ADMINISTRATIVE APPLICATION CHECKLIST

Chaco 2306-19E #189H
 30-043-21188
 NSL 7139
 NSP 200
 WPX Energy
 120782
 well
 - Chaco 2306-19E
 #189H
 30-043-21188

Re: Request for Administrative Approval of a 200-acre non-standard project area in the Lybrook Gallup Oil Pool (42289) and for non-standard location for the Chaco 2306-19E #189H, API: 30-043-21188

WELL LOCATION AND ACREAGE DEDICATION PLAT

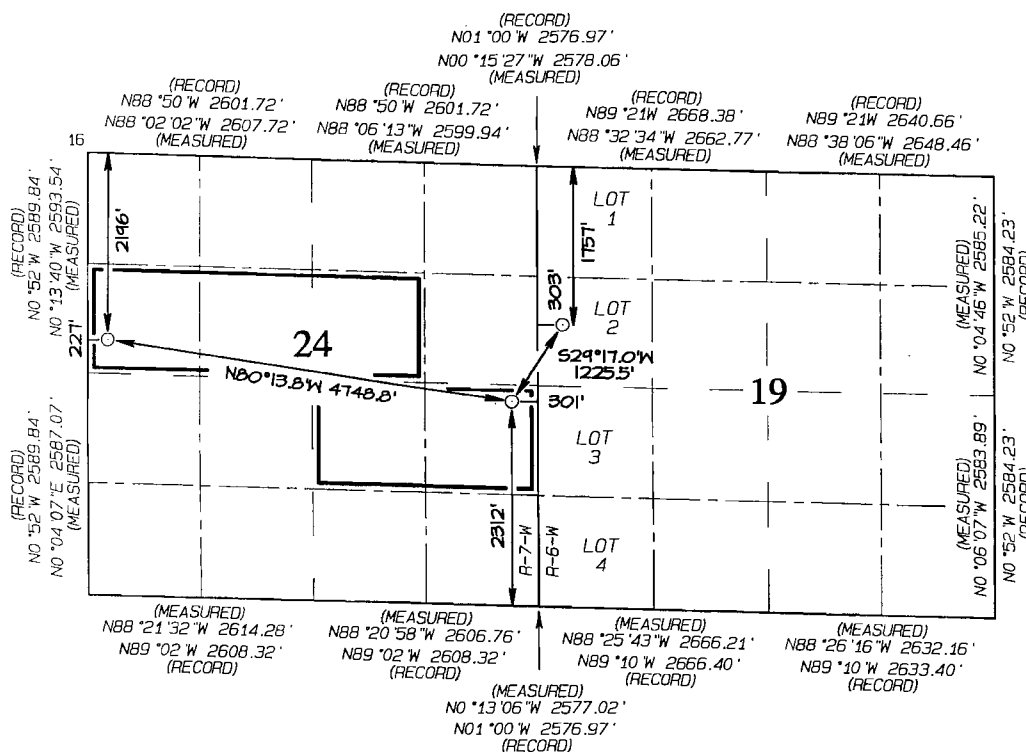
Can you sign and e-mail me C102's for the 188H and 189H? The C-102 has the survey signed, but not company representative.

Ms. Riley:
Can you sign and e-mail me C102's for the 188H and 189H? The C-102 has the survey signed, but not company representative.
Thank You
Michael McMillan

I'm sorry Michael. We sign the official "As Drilled" C-102s and they are already on record with the OCD. I thought that the copies I send in my NSL application are just courtesy copies not requiring signatures. I will get these to you.

Ms. Riley
IF they are as-drilled, then no signature is required.
How is the letter going for the allowables we discussed today?
Michael McMillan

I'm sorry Michael. We sign the official "As Drilled" C-102s and they are already on record with the OCD. I thought that the copies I send in my NSL application are just courtesy copies not requiring signatures. I will get these to you.
